From: Shadab Sukri
Sent: 05 June 2024 14:56
To: Nimisha Jadhav
Cc: Shama Nair; Murchana Devi; Shashank Mahadik
Subject: Re: Invoice approval - Muffin Designs Solutions -Gordon Ramsay _ Delhi T1

Subject: RE: Gordon Ramsay _layout options and mood boards

Please find attached layout options and mood boards for the Gordon Ramsay unit in Delhi airport.

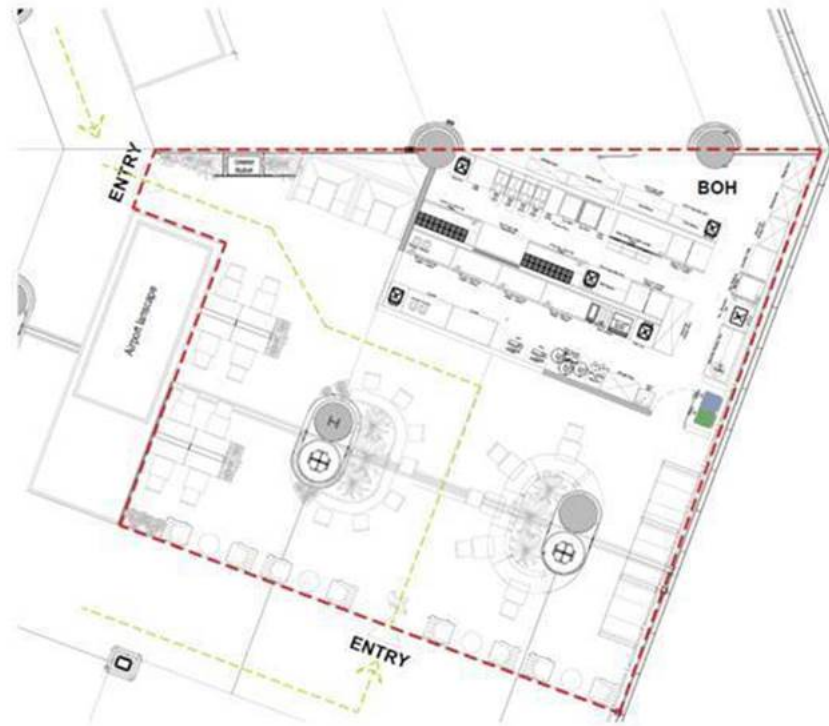
The approved furniture layout is attached below, add the revised kitchen layout, and 3/4bar stool in front of the bar counter. Check if any seating has to be modified to accommodate the bar stool.

OPTION-1 Layout Plan _ (Ref: Edinburgh)

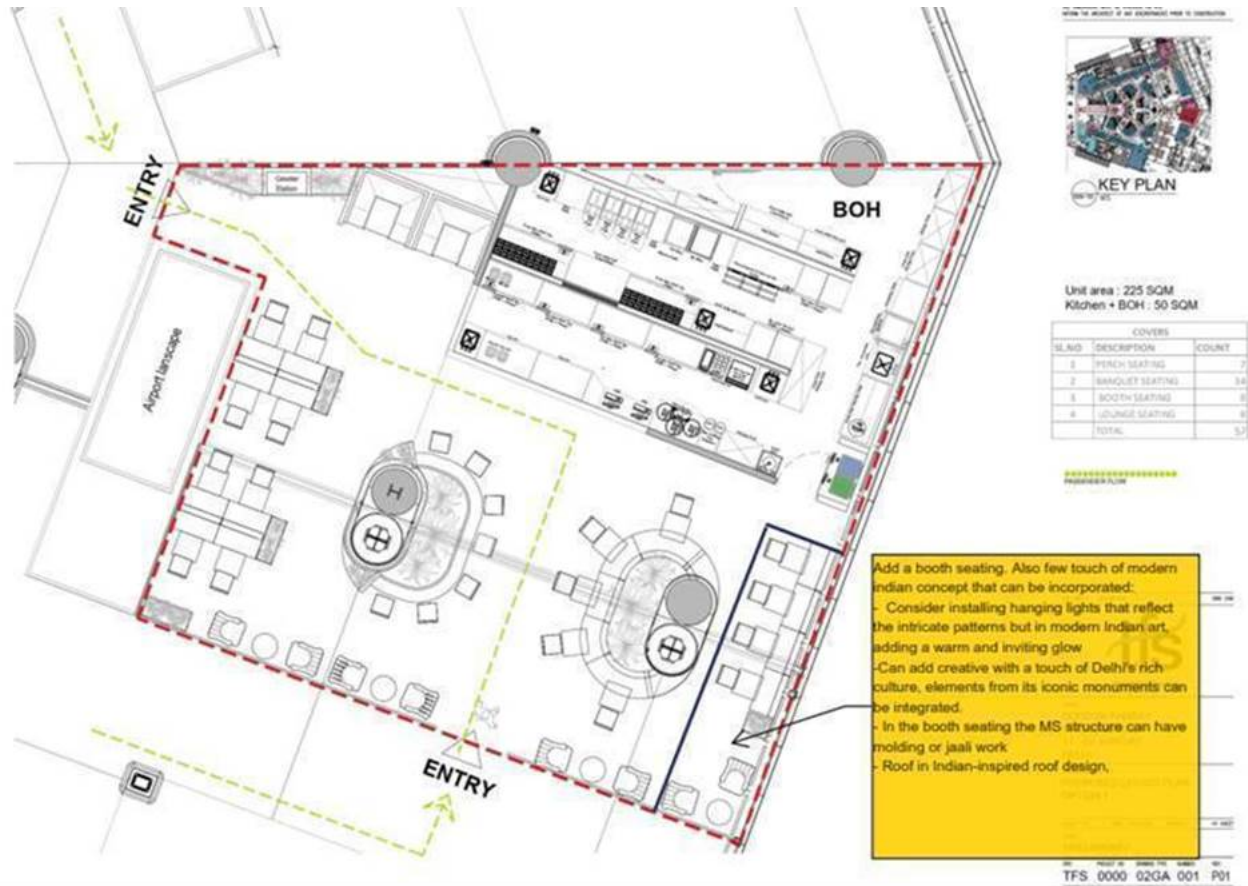
As discussed, PFA the comments for Indian touch. Add a booth seating. Also few touch of modern indian concept that can be incorporated:

- Consider installing hanging lights that reflect the intricate patterns but in modern Indian art, adding a warm and inviting glow
- Can add creative with a touch of Delhi's rich culture, elements from its iconic monuments can be integrated.
- In the booth seating the MS structure can have molding or jaali work
- Roof in Indian-inspired roof design,

Please revise and share the mood board and layout on or before Friday for brand approval.
